**TOWN OF BAY HARBOR ISLANDS
PLANNING AND ZONING BOARD**

**TOWN OF BAY HARBOR ISLANDS
COMMUNITY DEVELOPMENT
MEMORANDUM**

Subject: Proposed Single-Family Residence Addition / Renovations
9555 Broadview Terrace
Bay Harbor Islands Acct. No.: MB2015-164
MMPA Acct. No.: 01-0702-1055

SP-1.

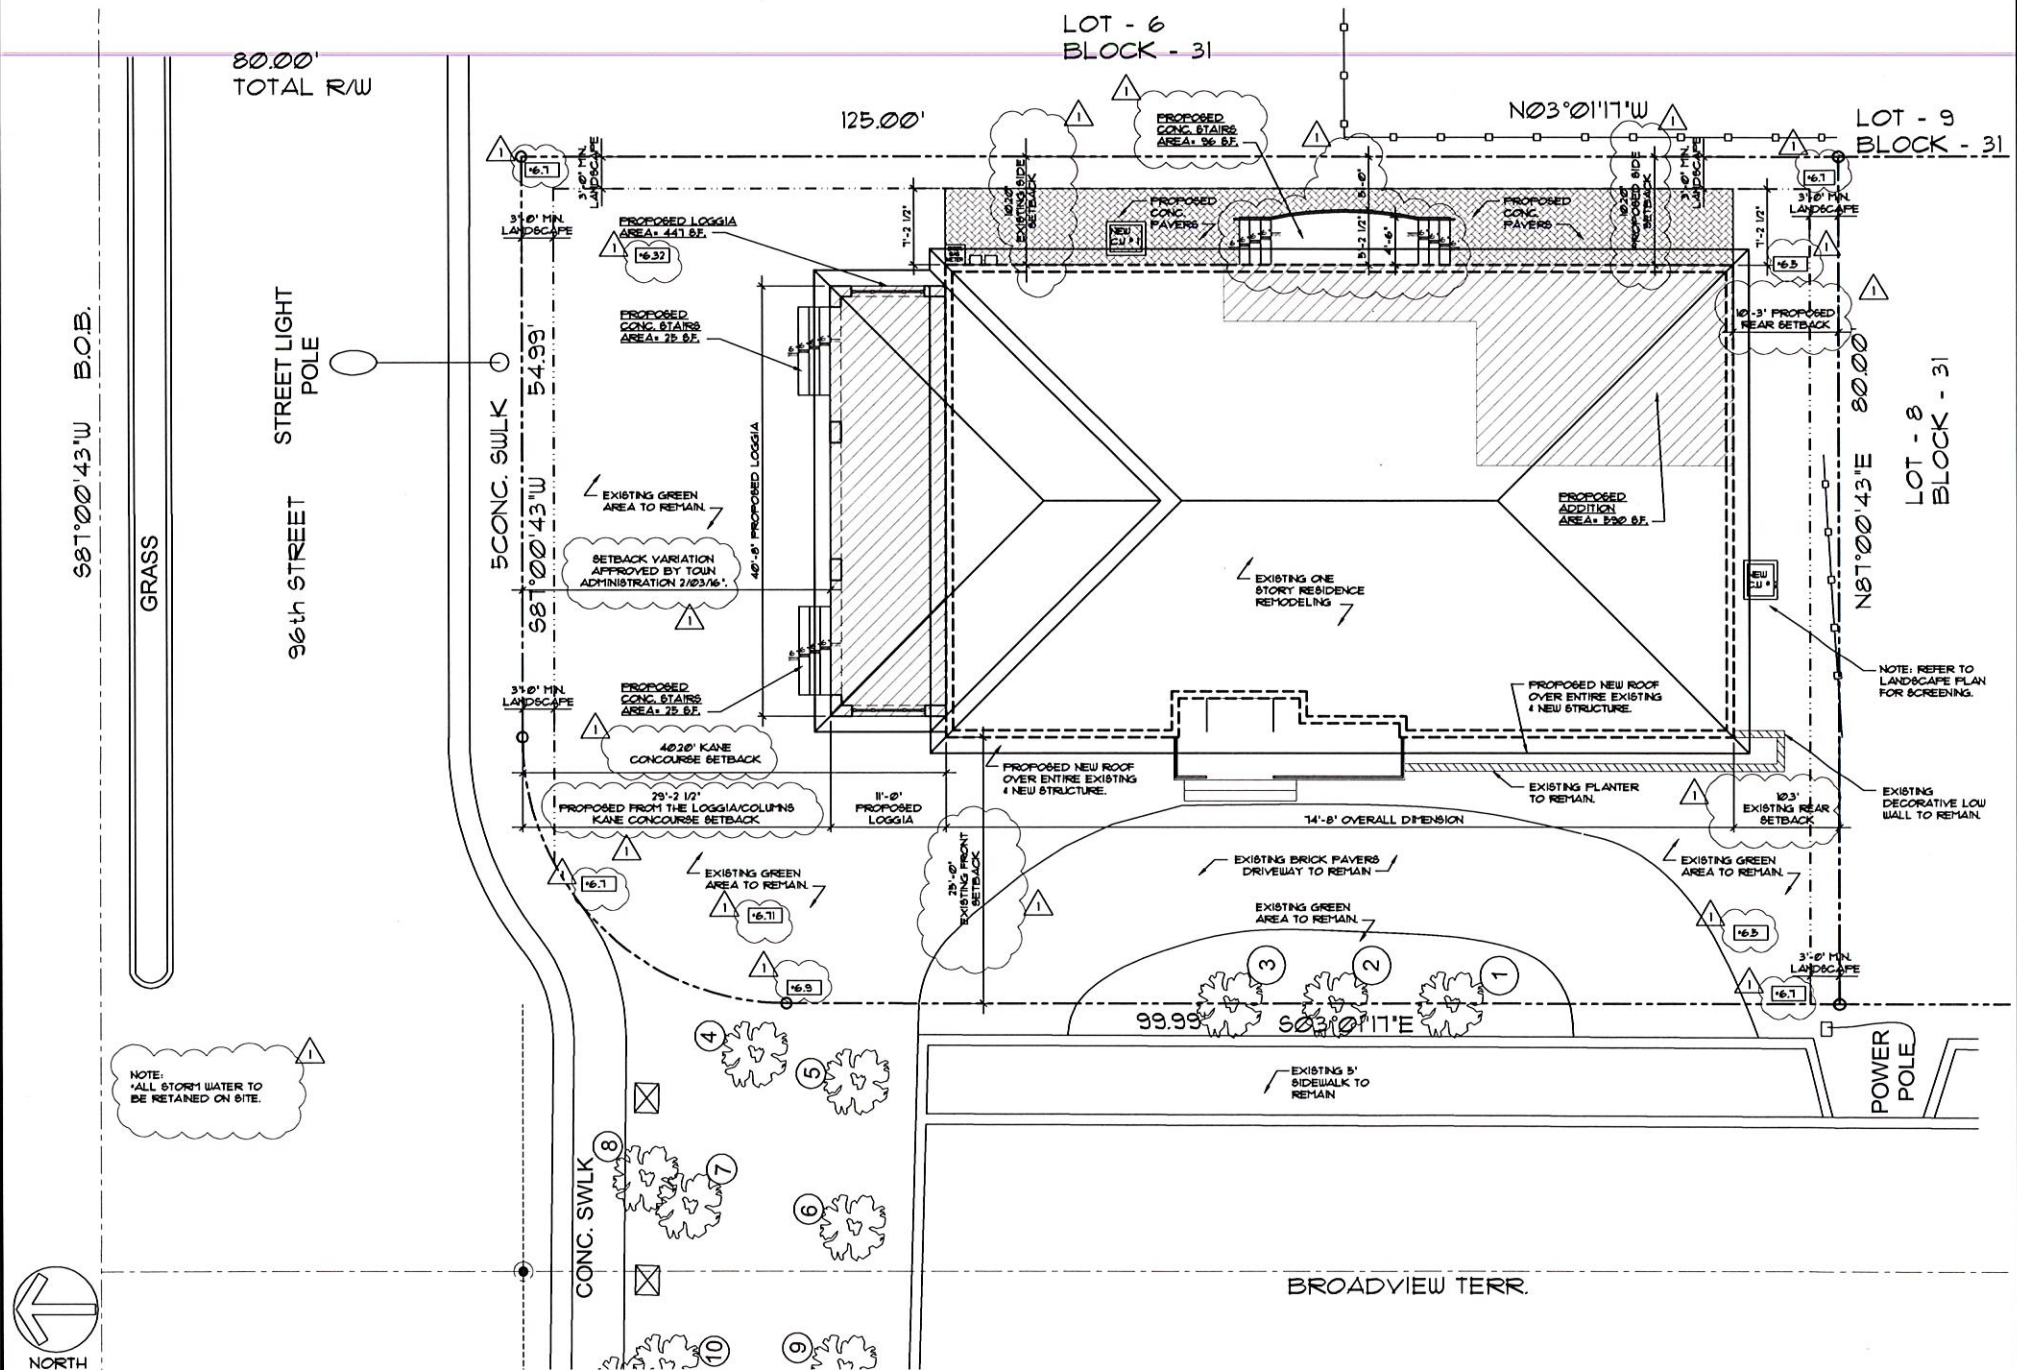
In early 2016 the PZB reviewed / approved a new 2-story single-family for this site. The owners decided to not pursue the construction of a new residence but rather decided to renovate the existing home with additions. During the 2016 PZB review an exterior patio was proposed on the north side of the home. A loggia is now proposed over that patio area. The main house and loggia (trellis) meet the minimum setback requirements (40' main house).

It should be noted that there will be no solid fence in this renovation along the north side of the property (along Kane Concourse), only a dense hedge. The previous plans included a fence / wall.

- 1) This approval is based on the plans prepared by LLR Architects Inc. dated June 29th, 2017 and Landscape Plans dated August 1st, 2017 with any modifications required by the PZ Board. All modifications to the above plans shall be reviewed by Town staff and may require re-approval by the PZB if felt to be substantial.
